GEORGE C. MARSHALL

SA-513/SL-1
PM-MO-10-71

REVISION 5

LAUNCH MISSION RULES INPUT DOCUMENT

INTERNAL POWER ENVELOPE AM BATTERIES 1 THRU 8

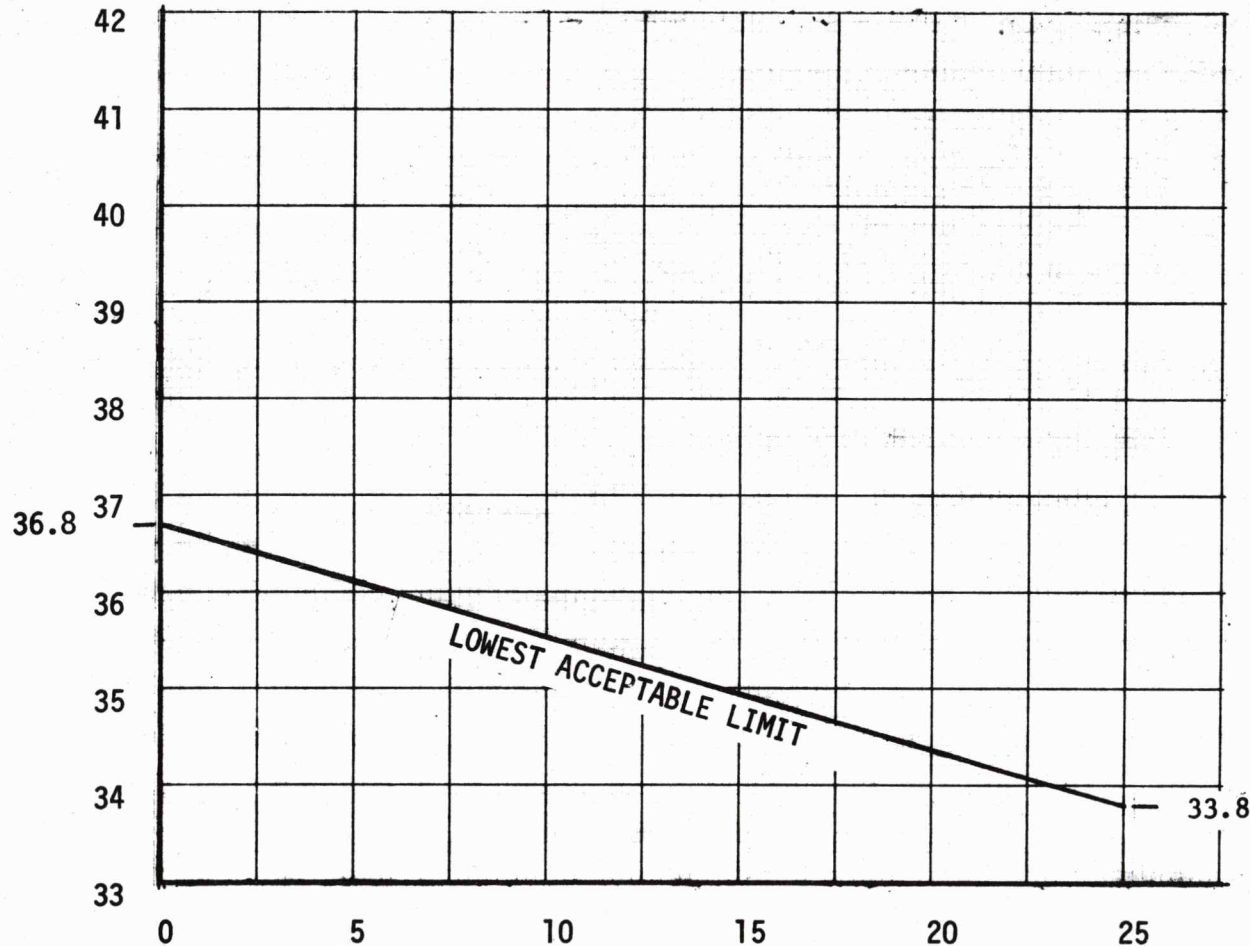
AM Figure 4

Revise AM Figure 4
